**Growth Management Department**  
Mid-Anastasia Design Overlay District  
January 11, 2024 Public Meeting  
MADRB 2023-03 Sunset View

**Subject:** **MADRB 2023-03 Sunset View**, request waivers to the setback, landscape buffer, and signage requirements of the Mid-Anastasia Overlay District. This request is a companion application to PUD 2023-15 Sunset View PUD, which proposes to rezone approximately 2.42 acres of land from CG, RS-3 and OR to a Planned Unit Development to allow a maximum of 3 residential units and 7,854 sqft of commercial uses.

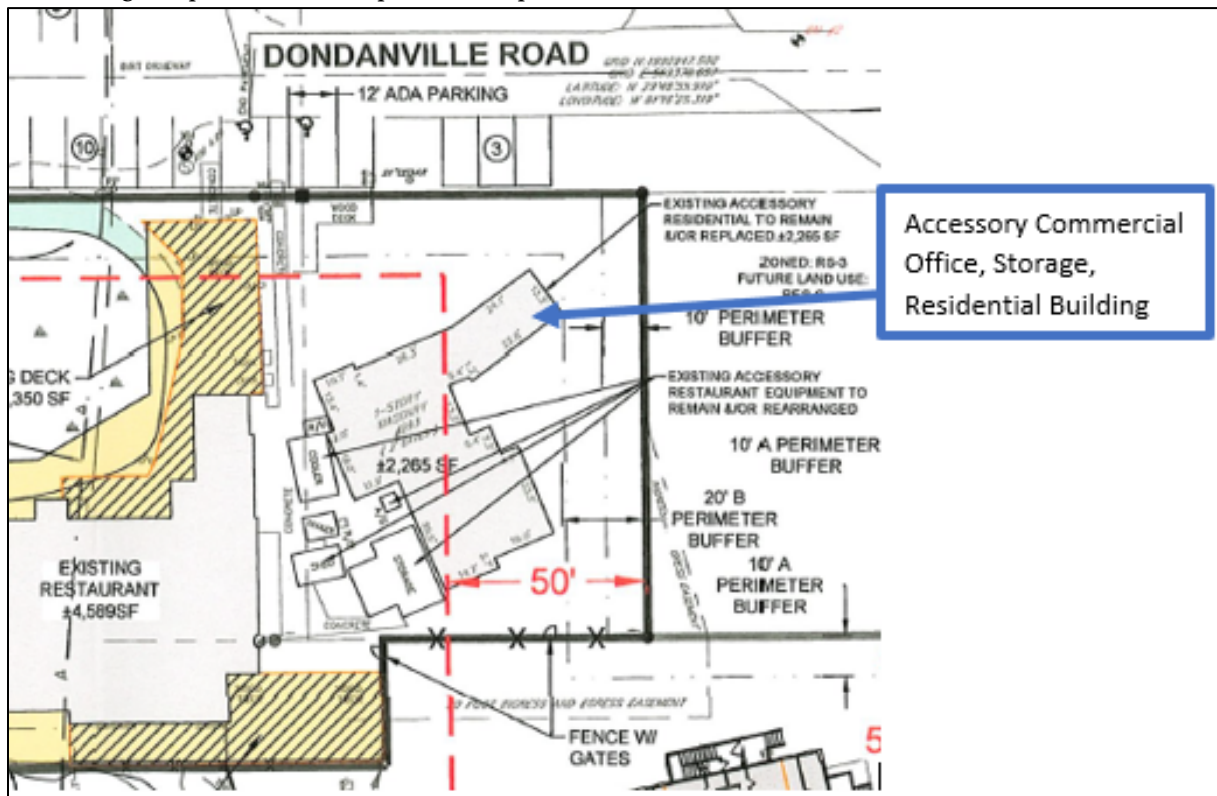
**Commercial Office/Storage/Residential Building –**

- Requested waiver from LDC Sec. 3.08.05.D and 3.08.05.E.2
  - LDC requires accessory structures to be placed no closer to the road than the main building

- LDC requires building heights of 20' or less, a 30-foot Side and Rear Yard setback from a neighboring residential site
  - LDC requires building heights more than 20', a 50-foot Side and Rear Yard setback from a neighboring residential site

- Proposed Request:
  - Allow structure to remain in current placement
  - Allow reconstruction of structure and ability to build higher than existing
  - Allow a \_\_\_\_\_-foot Side and Rear Yard setback from the neighboring residential sites

- Justification: the existing restaurant/office/storage building is an Accessory Structure; it is currently approximately 20 feet in height and would require a front yard setback of 15 foot from Dondanville Road and 50 foot from the neighboring residential site located to the east. This existing building currently violates LDC Section 3.08.05.D and 3.08.05.E.2 as the building is approx. 20 feet from the side property line of the adjacent residential use and is located closer to the roadway than the main use structure. The applicant is requesting that this structure be allowed to remain and replaced onsite; the applicant is also wanting permission to rebuild the structure higher than the existing 20' height explaining that the existing structure floods on occasion. An increased elevation will be required to mitigate flooding and allow a different roof style; the applicant also does not want to remove any existing large trees on the site. The existing structure was constructed prior to the Overlay regulations.

- NOTE: the amount of reduced setback is unknown and will need to be verified by the applicant at the hearing.

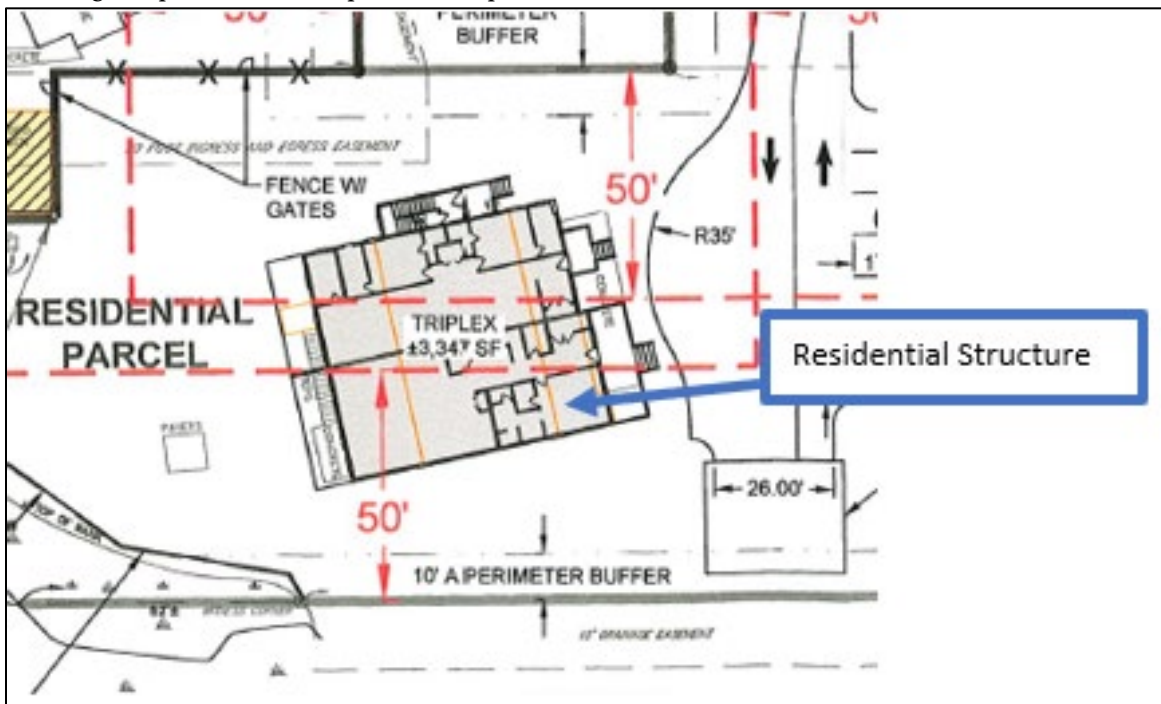
**Residential Structure –**

- Requested waiver from LDC Sec. 3.08.05.D
  - LDC requires a 50-foot setback from all neighboring residential sites
- Proposed Request:
  - Allow structure to remain in current placement

- Allow reconstruction of structure and ability to enlarge
  - Allow a 20-foot setback from the neighboring south residential site
  - Allow a \_\_\_\_\_-foot setback from the neighboring north residential site

- Justification: the existing residential structure located to the southeast of the site is currently placed within the required 50-foot setback from the existing residential sites to the north and south. This existing building currently violates LDC Section 3.08.05.D as it is approx. 30 feet from the north and south property line. The applicant is requesting that this structure be allowed to remain and be allowed an expansion as a tri-plex. The applicant states the home conversion would meet a 20' setback from the south property line. The existing structure was constructed prior to the Overlay regulations.

- NOTE: the amount of reduced setback from the property to the north is unknown and will need to be verified by the applicant at the hearing.

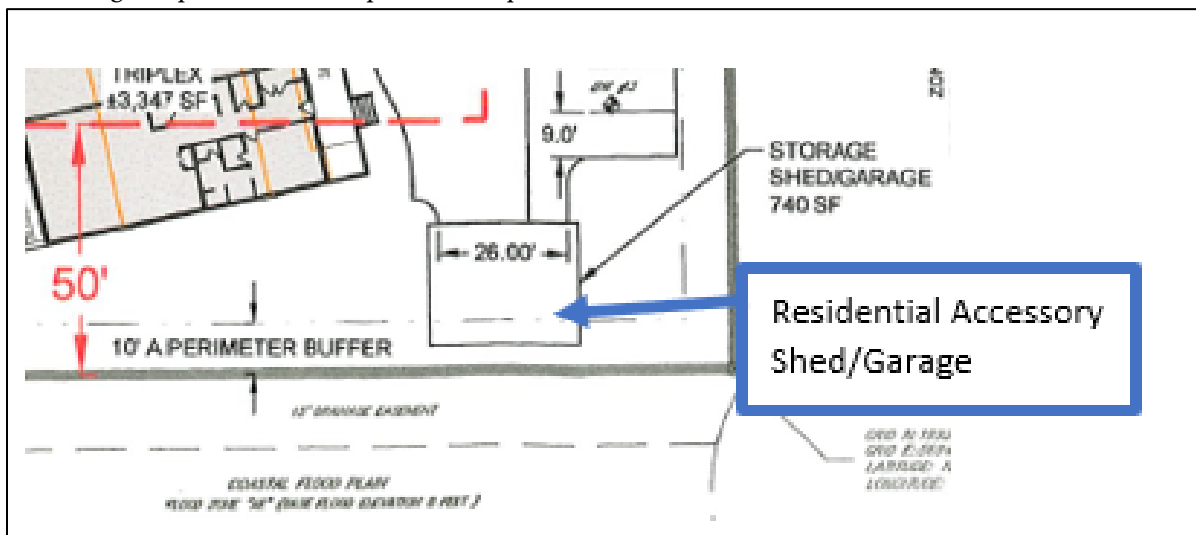
**Residential Accessory Shed/Garage –**

- Requested waiver from LDC Sec. 3.08.05.D
  - LDC requires building heights of 20' or less, a 30-foot Side and Rear Yard setback from a neighboring residential site
- Proposed Request:
  - Allow structure to remain in current placement
  - Allow shed to remain at a 5' side yard setback
  - Allow potential garage to be placed at a 10' setback
  - If shed or garage is removed, it would be replaced at a 10' side yard setback
- Justification: the existing the existing structure located to the southeast of the site is currently placed within the 30-foot setback from existing residential sites to the south. This existing structure violates LDC Section 3.08.05.D as it currently sits 5 feet from the property line. The applicant is requesting that this structure be allowed to stay and be allowed an expansion. The existing structure was constructed prior to the Overlay regulations.

Image 3:

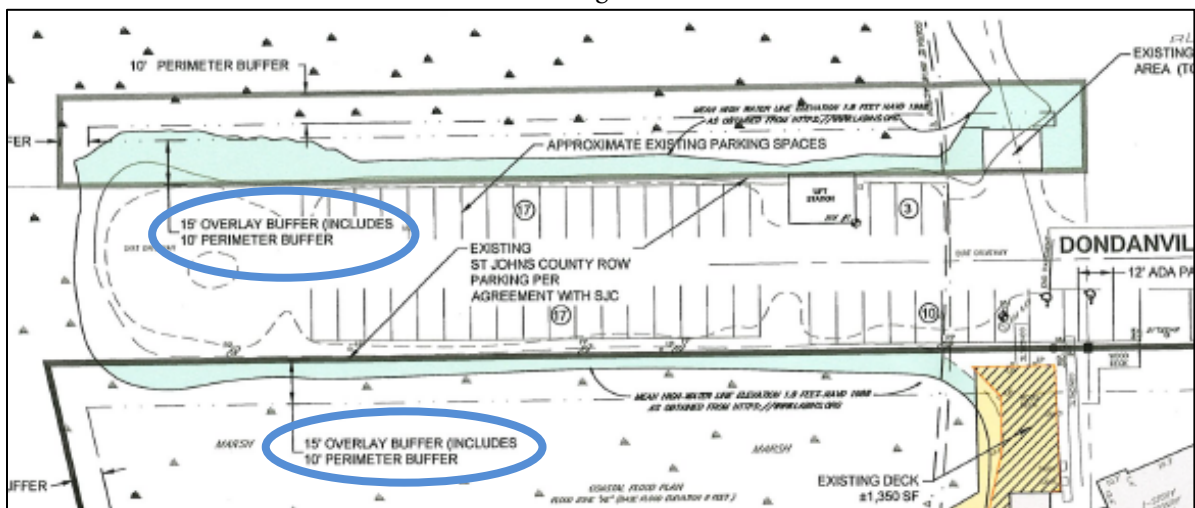
**Commercial Parcel –**

- Requested waiver from LDC Sec. 3.08.06.A.2 and 3.08.06.B
  - LDC requires a 15-foot landscaped buffer along the roadway
- Proposed Request:
  - Require no additional buffering along the marsh area parking to the north and south along Dondanville Road; allow the current landscaping to remain

- Allow the deck to remain within the buffer
  - Allow a reduced 10' buffer along the restaurant frontage
  - Allow a 6' fence within the buffer in front of the Commercial Office/Storage/Accessory structure

- Justification: as provided within the applicant's narrative and above review, the applicant is requesting a waiver from LDC Section 3.08.06 to allow for a reduction in buffering requirements for the commercial parcel specifically along the front marsh area and the existing front decking area. The existing site to the west (along the parking area) appears to contain a water line that would not allow the above buffering requirements (Image 1). This area also contains the existing decking and proposed decking expansion; the decking may be similar to the above LDC Section 3.08.06.D which allows sidewalks and seating placement within the buffers (Image 2). The existing site in front of the accessory structure currently contains a wood fence at approximately 6 feet in height to provide buffering (Image 3). The applicant has provided the required buffering notation on the submitted plans (Image 4).

Image 5:

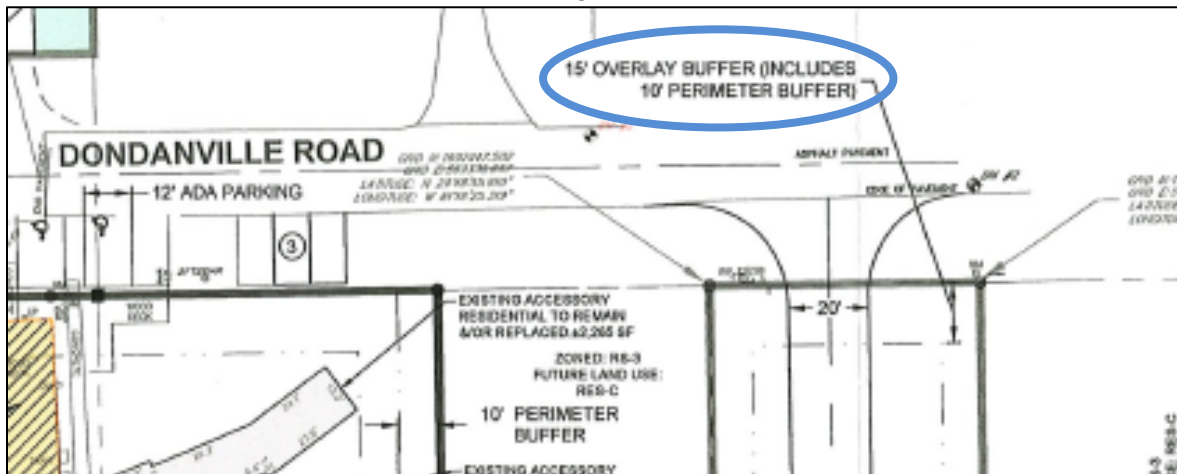
**Residential Parcel –**

- Requested waiver from LDC Sec.Unknown
  - LDC requires LDC requires a 15-foot landscaped buffer along the roadway
- Proposed Request:
  - No Waivers appear to be requested
- Justification: the existing residential site only contains a limited amount of roadside frontage. The existing site appears to contain minimal buffering along with the residential driveway (Image 5). The applicant has provided the required buffering notation on the submitted plans (Image 6). It does not appear any waiver of buffering is being requested to the residential parcel.
- NOTE: the applicant will need to verify that no waiver to buffering is being requested on the residential parcel.
